**SUMMARY OF SUBMISSIONS**  
**Karbro Drive, Cardup 26 (L87) 143801 – Section 31 Reconsideration – SJ4210**

# Attachment 1

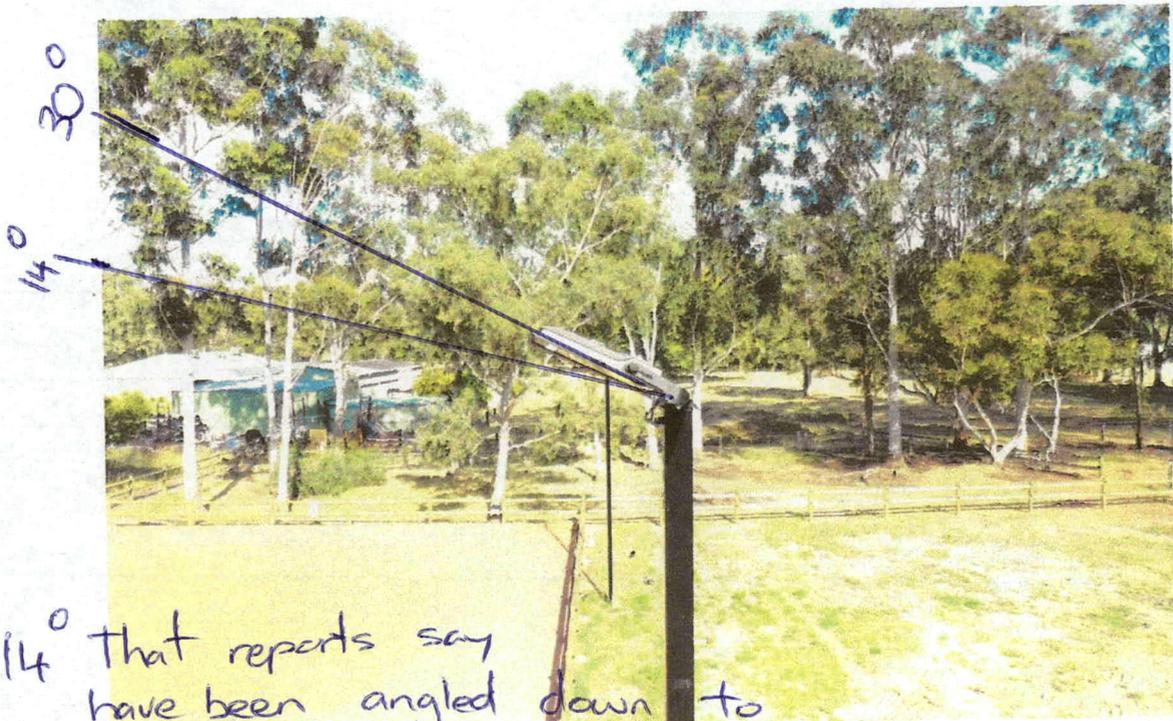
A total of 6 x Luminaires are installed at 7m height with a max allowable tilt angle of 35 deg to achieve compliance

14° that reports say  
have been angled down to  
28-30° Actual angle.

## Attachment 2.

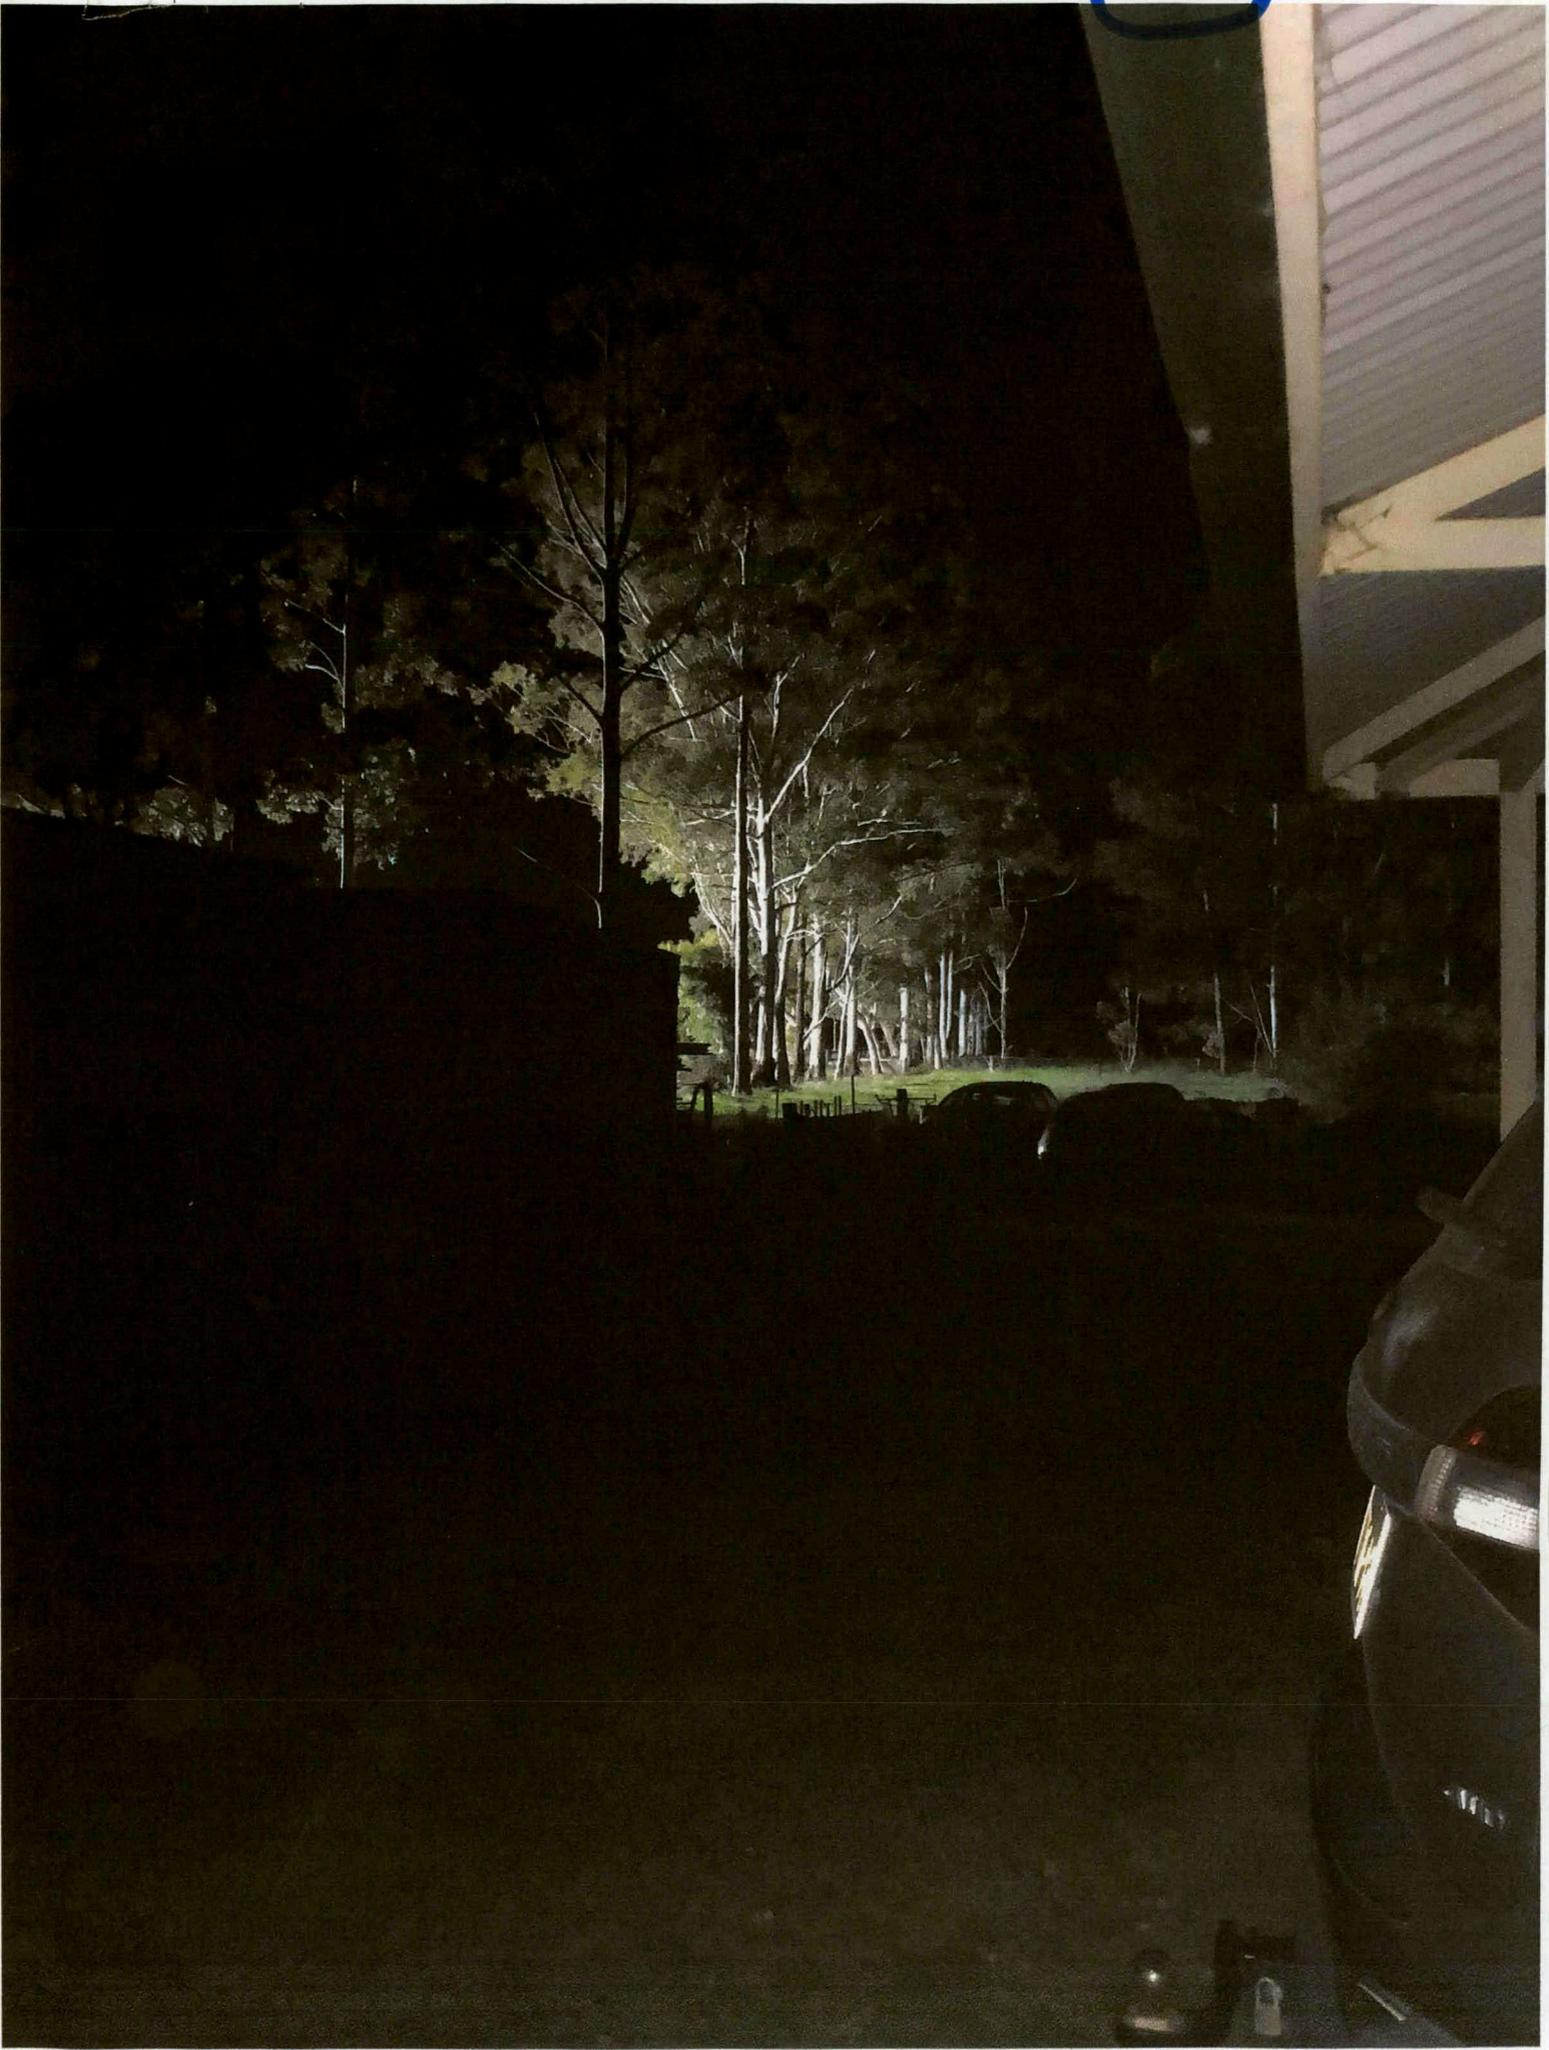
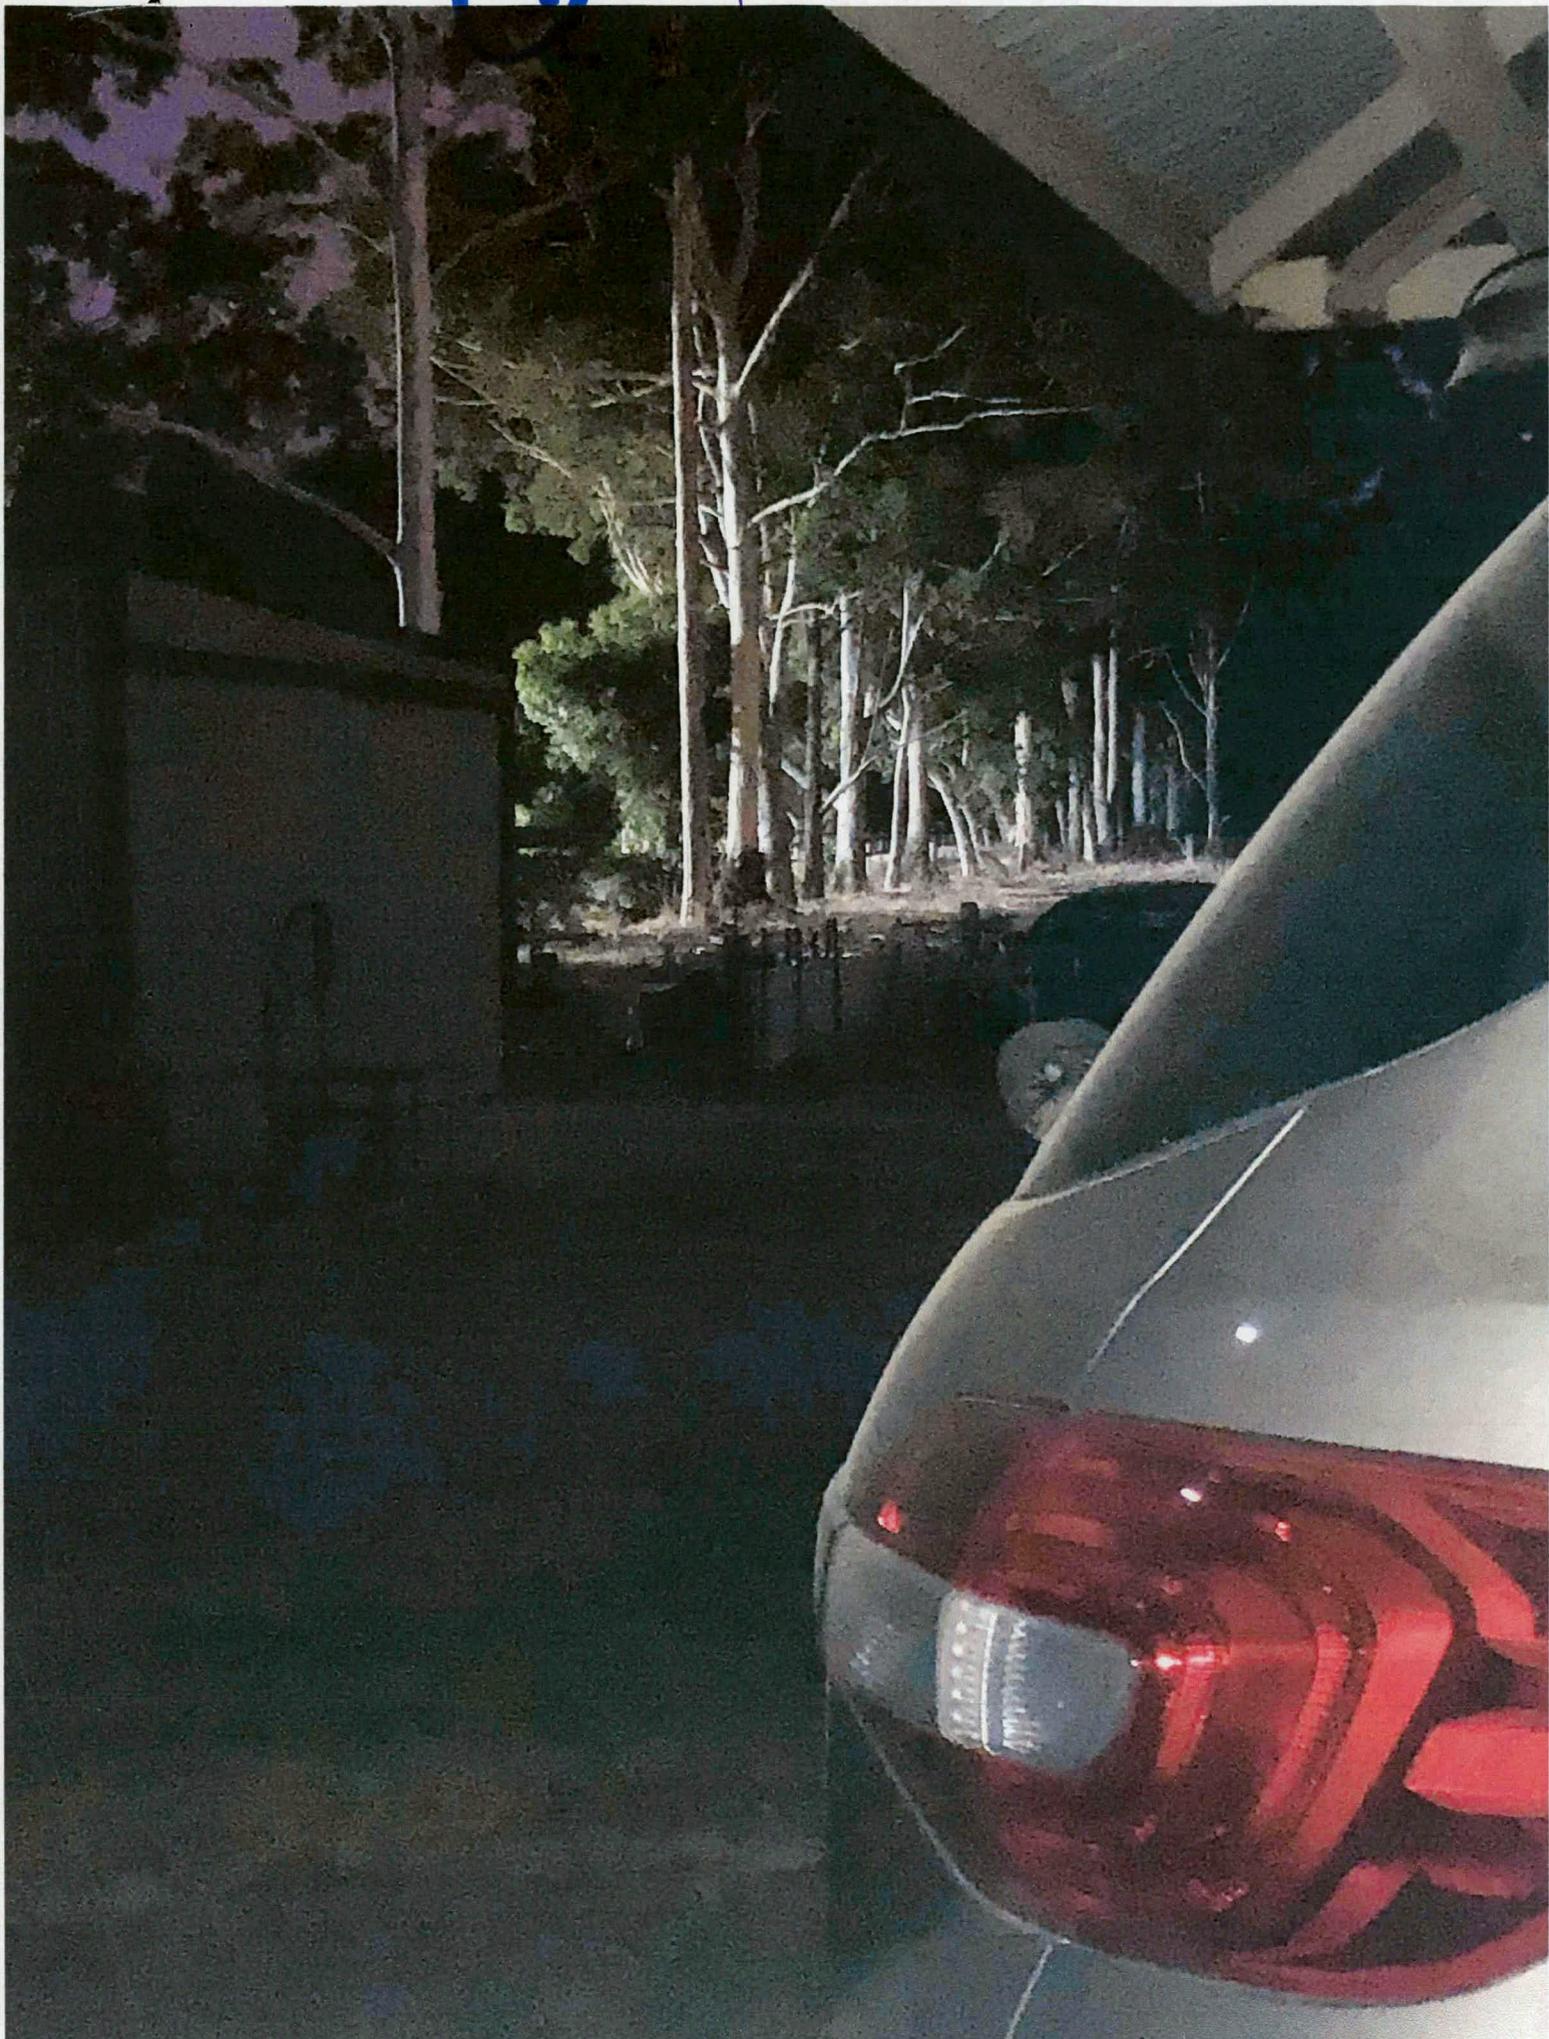
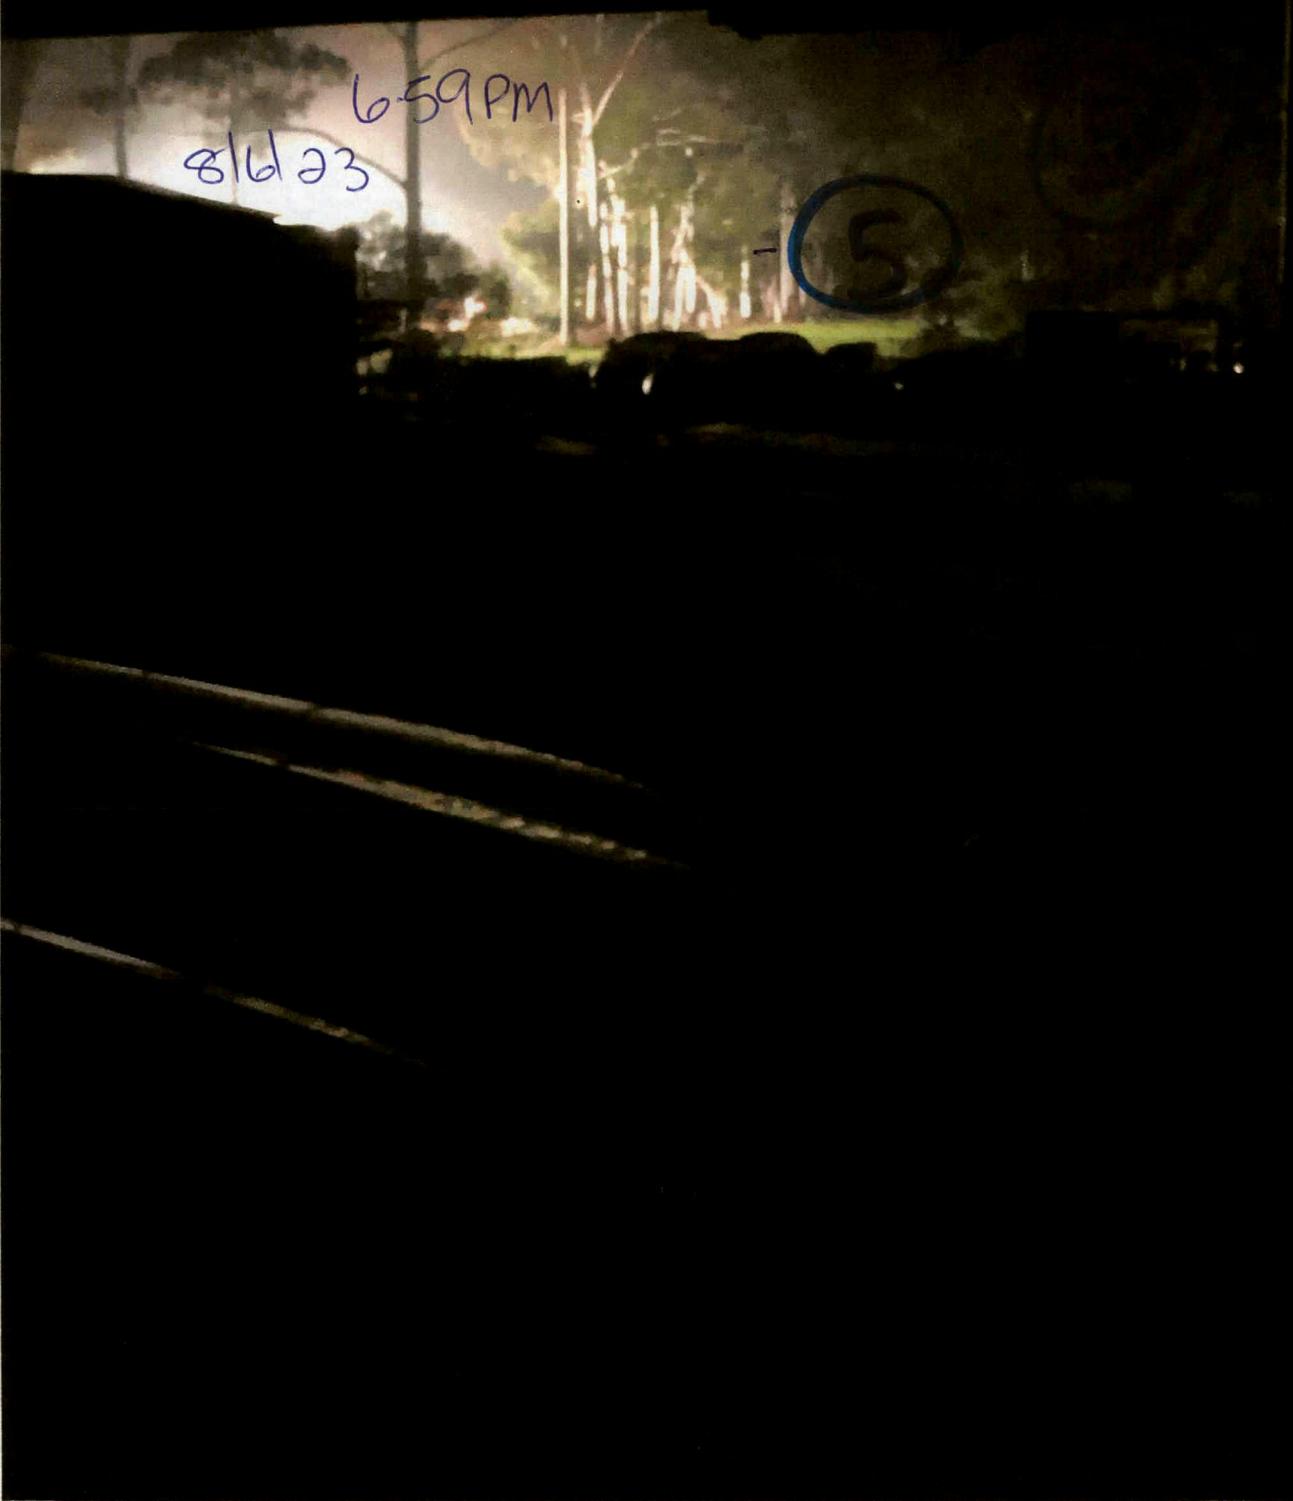
- 1) 18/5/22 — 9.02 PM
- 2) 28/7/22 — 6.32 AM
- 3) 16/9/22 — 6.34 AM From our front paddock
- 4) 3/1/23 — 8.10 AM
- 5) 8/6/23 — 6.59 AM
- 6) 28/6/23 — 6.06 PM
- 7) 6/7/23 — 5.49 AM on prior To 6 AM
- 8) 6/7/23 — 6.48 PM.

good comparison of no change  
in light spill from  
18/5/22 — 28/6/23
